Agenda
Hearing Examiner Meeting
Monday, July 12, 2021
Join the Zoom meeting [here](#)
Public Telephone Access: (206) 337-9723 or (253) 215-8782
Meeting ID No. 872 2126 7401

S2021-104 - Preliminary Plat of South Orchard

**CITY OF RICHLAND DEVELOPMENT SERVICES DIVISION
STAFF REPORT TO THE HEARING EXAMINER**

PROPOSAL NAME: South Orchard - Preliminary Plat

Sheet from Benton County Public Works representing trail request along north side of Reata Road

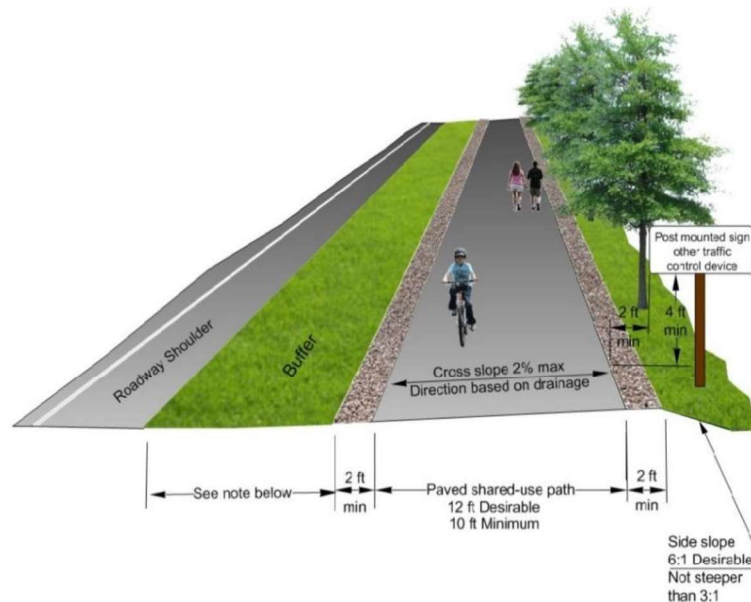
On the matter of trails, the Benton County Public Works Department submitted a comment letter requesting the trail proposed on the north side and parallel to

Reata Road, be constructed to Primary Trail standards as depicted in LUDR Section 5 where the LUDR only calls for the trail to meet Secondary Trail standards. The primary difference between the two trail types is, Primary Trails are ten (10) foot-wide paved trail surfaces and Secondary Trails are five (5) foot-wide soft surface trails (i.e. wood chips or gravel). Said comment letter is included herein as part of Exhibit 7.
